February 22, 1983

DOCKET NO. 50-266
STEAM GENERATOR REPAIR ALARA MEETING SUMMARY
POINT BEACH NUCLEAR PLANT, UNIT 1

AGENDA FOR NRC ALARA REVIEW MEETING FOR
STEAM GENERATOR REPLACEMENT
POINT BEACH NUCLEAR PLANT
JANUARY 27, 1983

HEALTH PHYSICS ORGANIZATION CHART

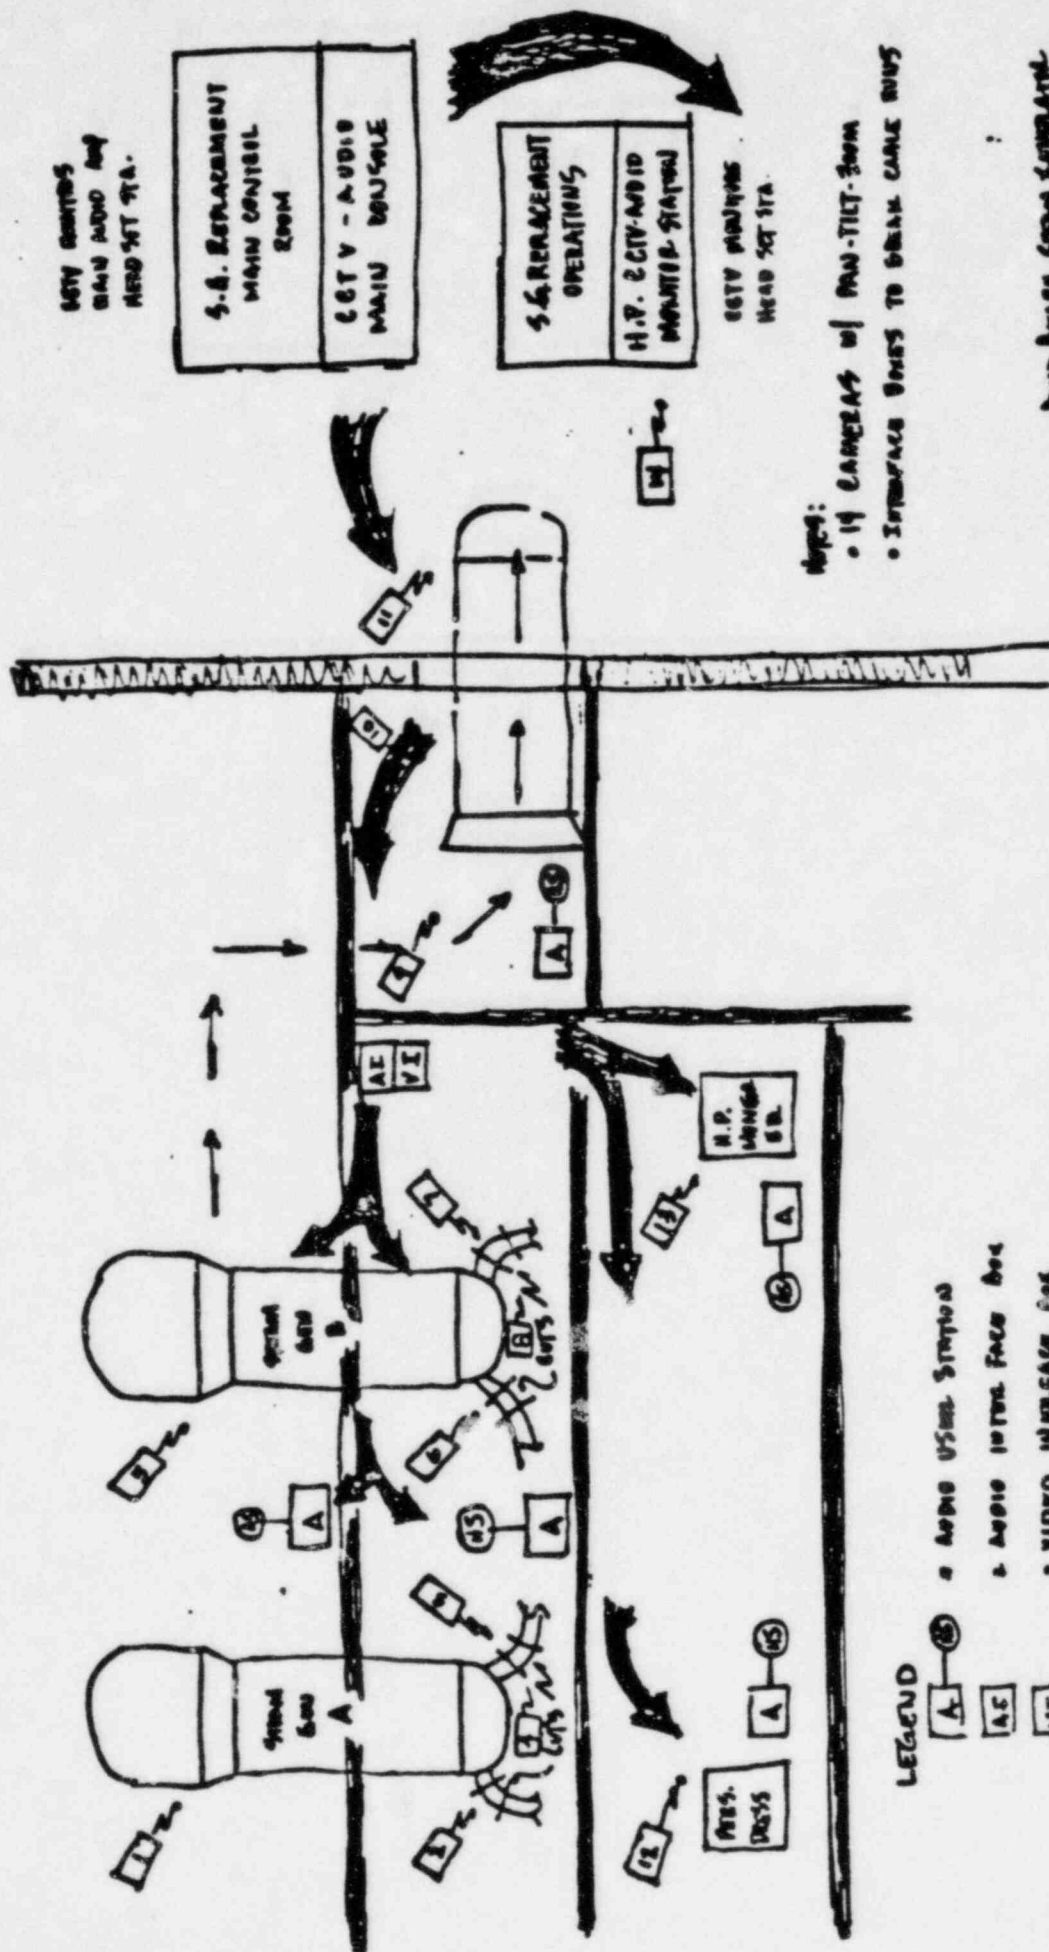
Mr. T. G. Colburn suggested that the Wisconsin Electric Health Physics Coordinator be made a member of the Manager's Supervisory Staff. In response to this suggestion, the Health Physics Coordinator will in the near future begin attending Management Supervisory Staff meetings which relate to steam generator replacement and will serve as an alternate member for the duration of the steam generator replacement.
